Part C

Additional Information Required

C.1 STATEMENT OF COMMITMENTS

Figure 27 - Access and edge treatments to Conservation Area.

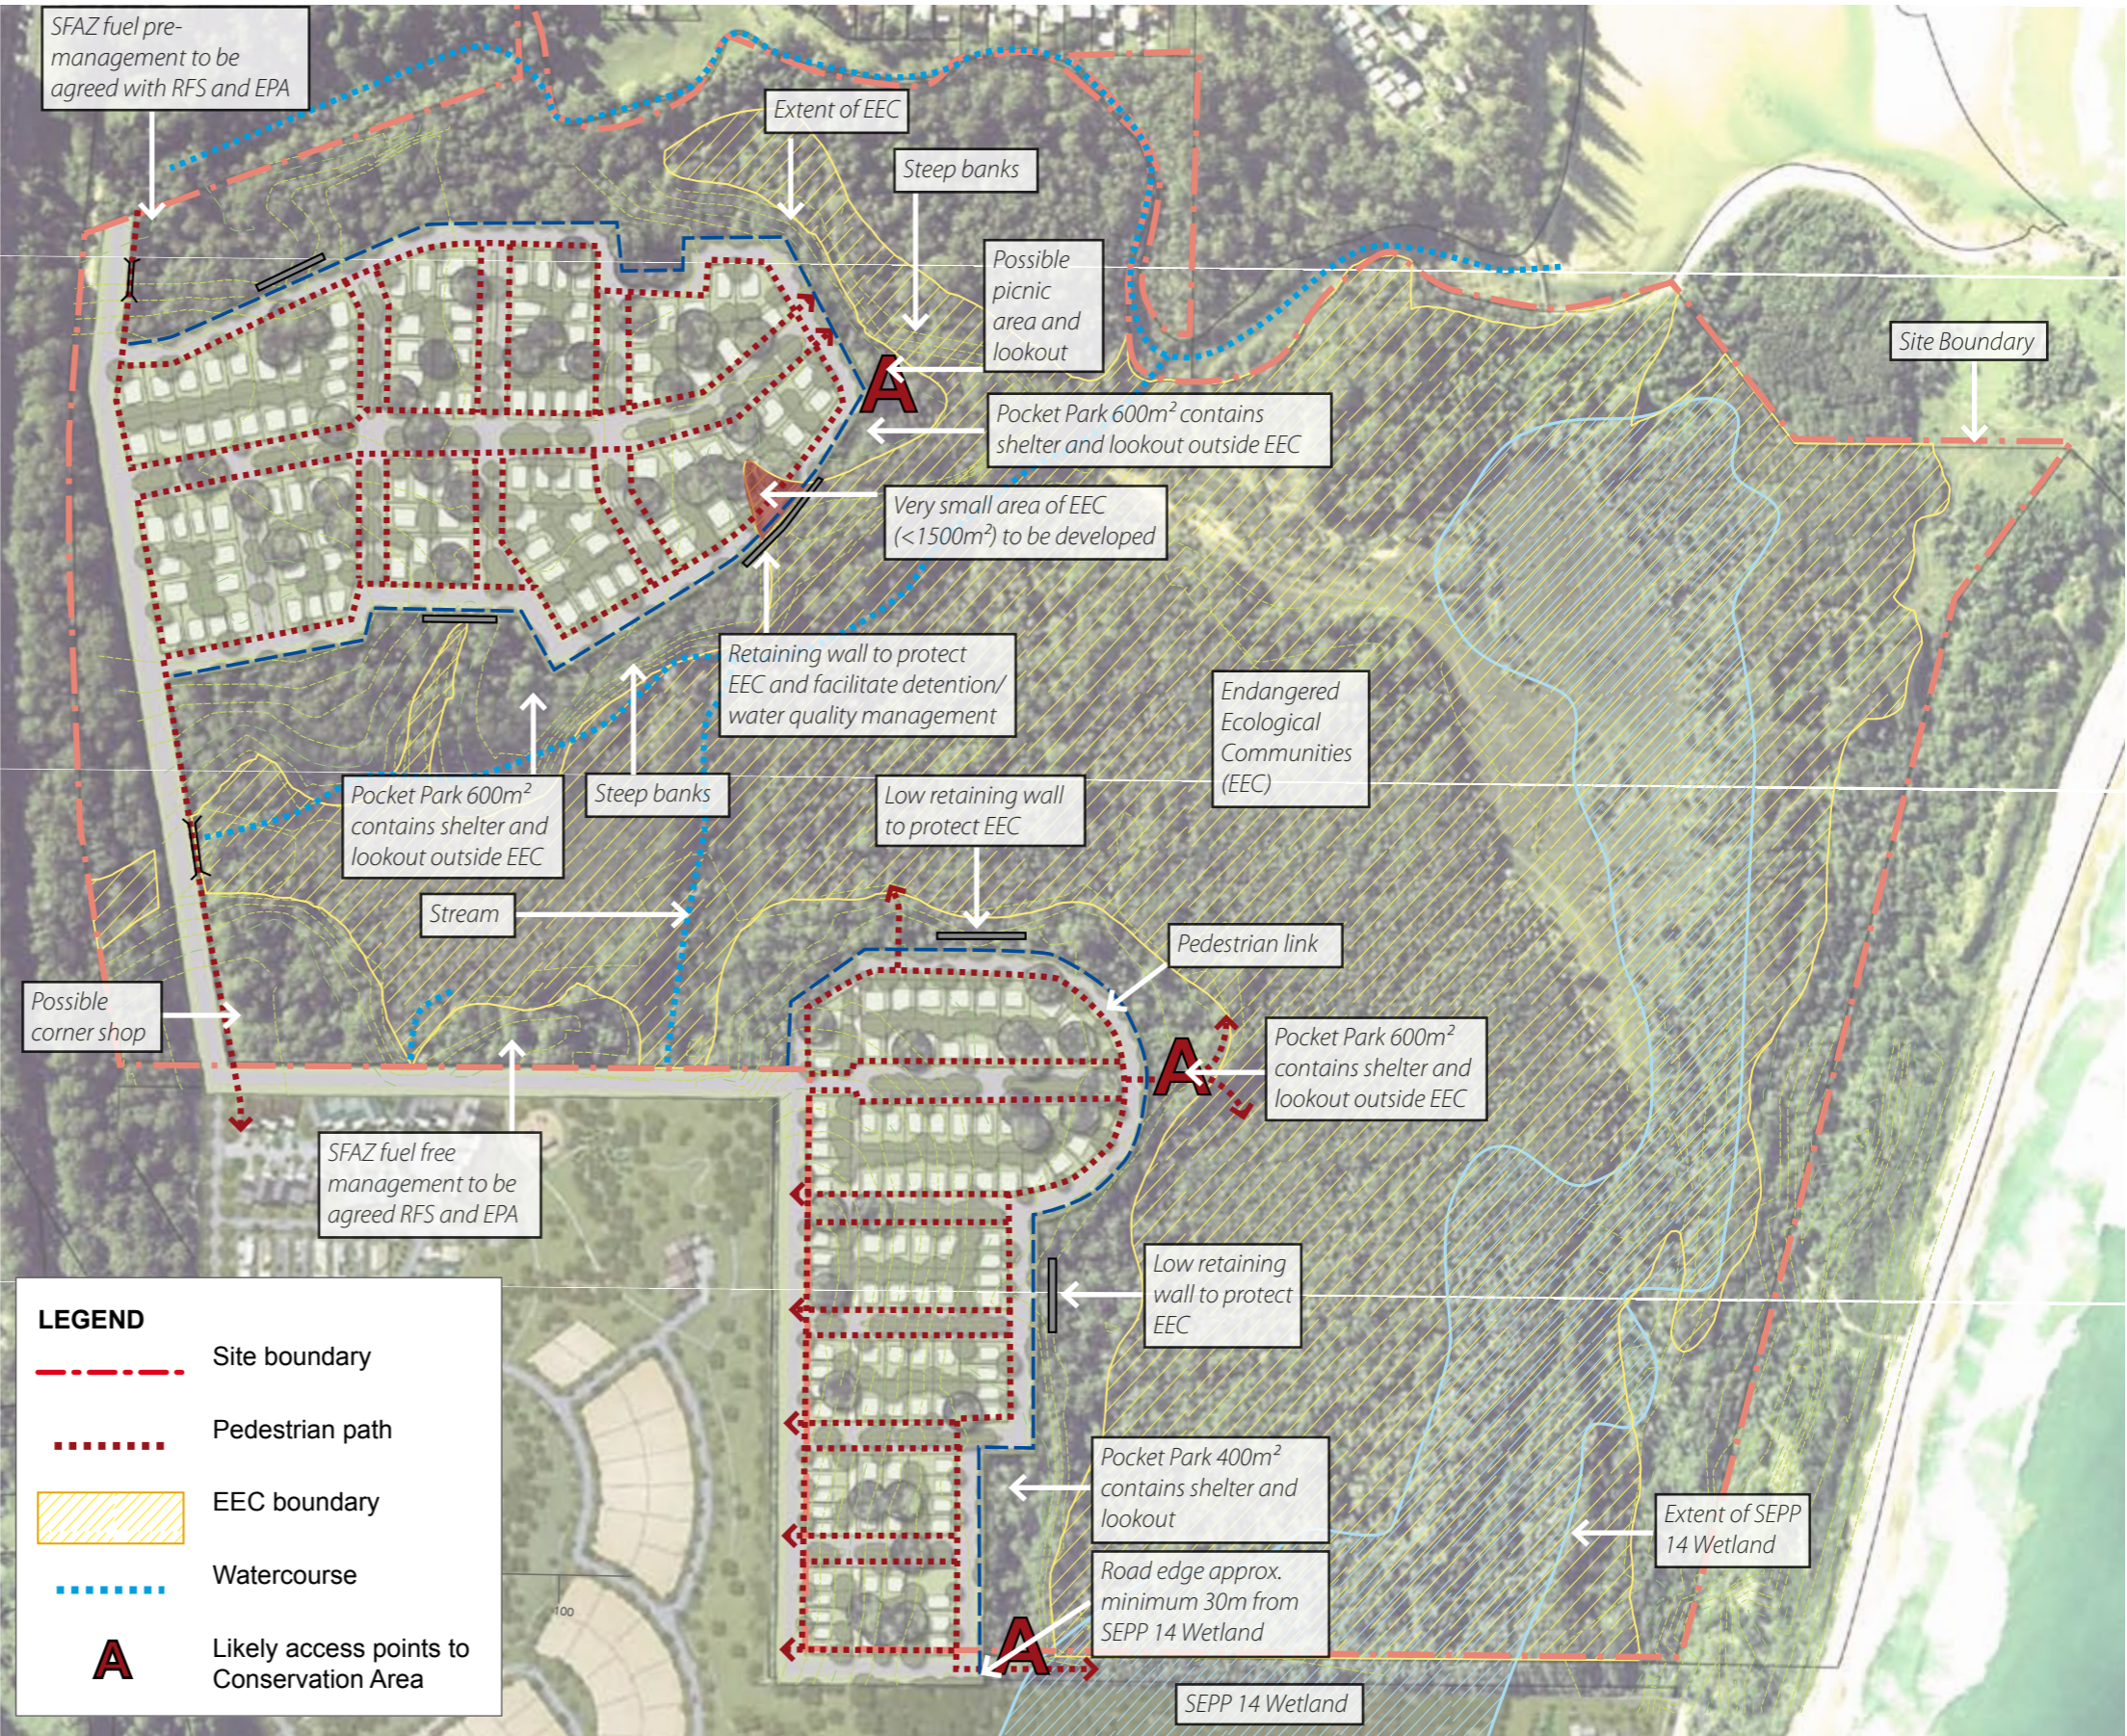
- Potential pedestrian connections will connect with the footpath system in residential areas on the inside of the perimeter road. (See **Figure 27** on this page);

Access to the Conservation Area is to be controlled and managed by a variety of measures:

- Features such as roads, bio-retention swales, bollards and exclusion fencing will be provided to identify the physical edge of the "Conservation Area";

- The precise location of fencing, access points to the pathway system, local parks, picnic areas and parking areas will be resolved in consultation with Council, Department of Planning, DECC and DoL upon approval of the Preferred Project Plan and prior to the DA stage;

Fig 29 Sections of Edge Roads with Swale

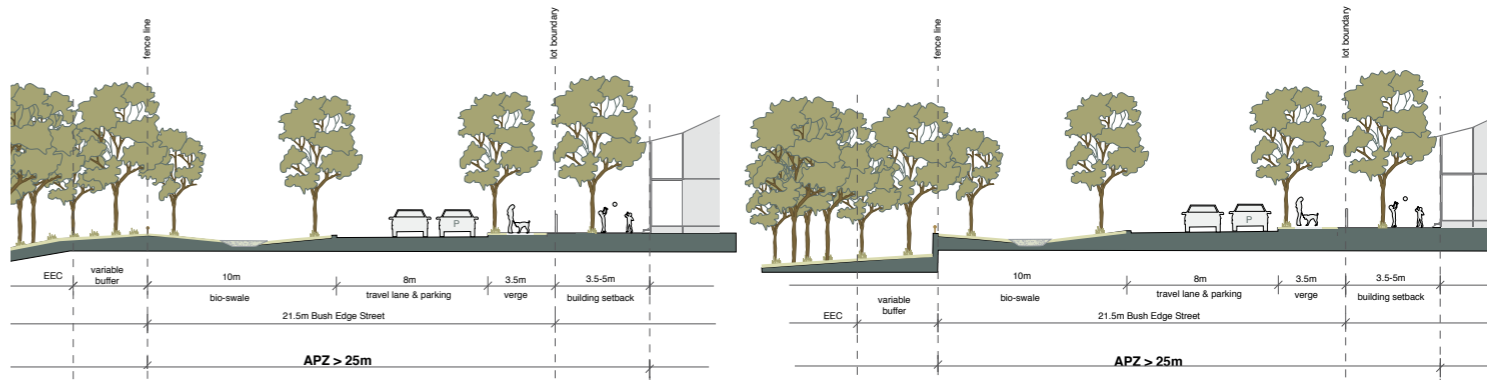
The perimeter swale width has been adjusted to 10m, not 8m or 8.8m (Figure 28 & 29).

Figure 31 - Approximate surveyed position of possible scarred trees.

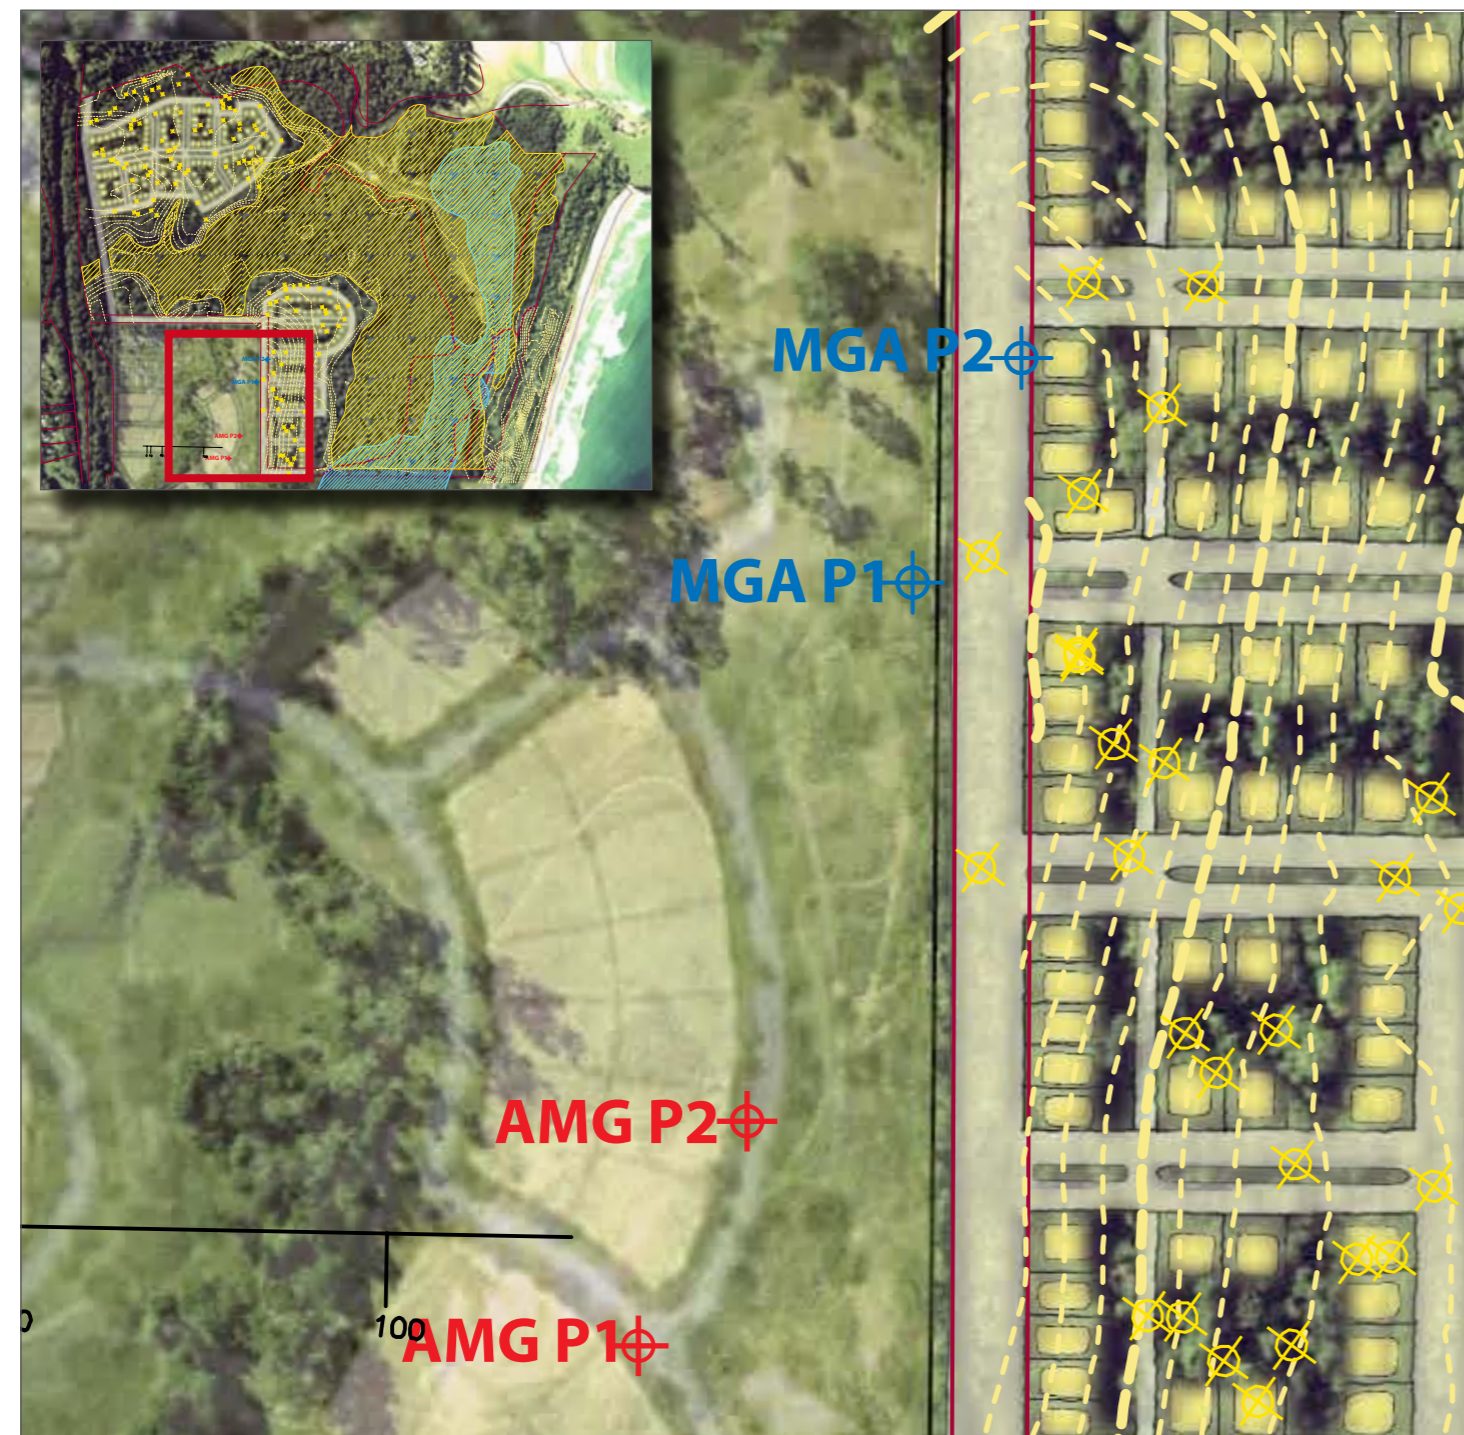
Previous archaeological surveys have revealed no significant issues impacting on proposed development. However, since the last report two possible scarred trees have been reported. These have been investigated and located (MGA P1 & P2, **Figure 31**). Both our consultant archaeologist and the DECC Regional Archaeologist doubt that they are of aboriginal origin, however further investigations will be required to clarify this and to determine if they are in conflict with development proposals and what actions should be taken.
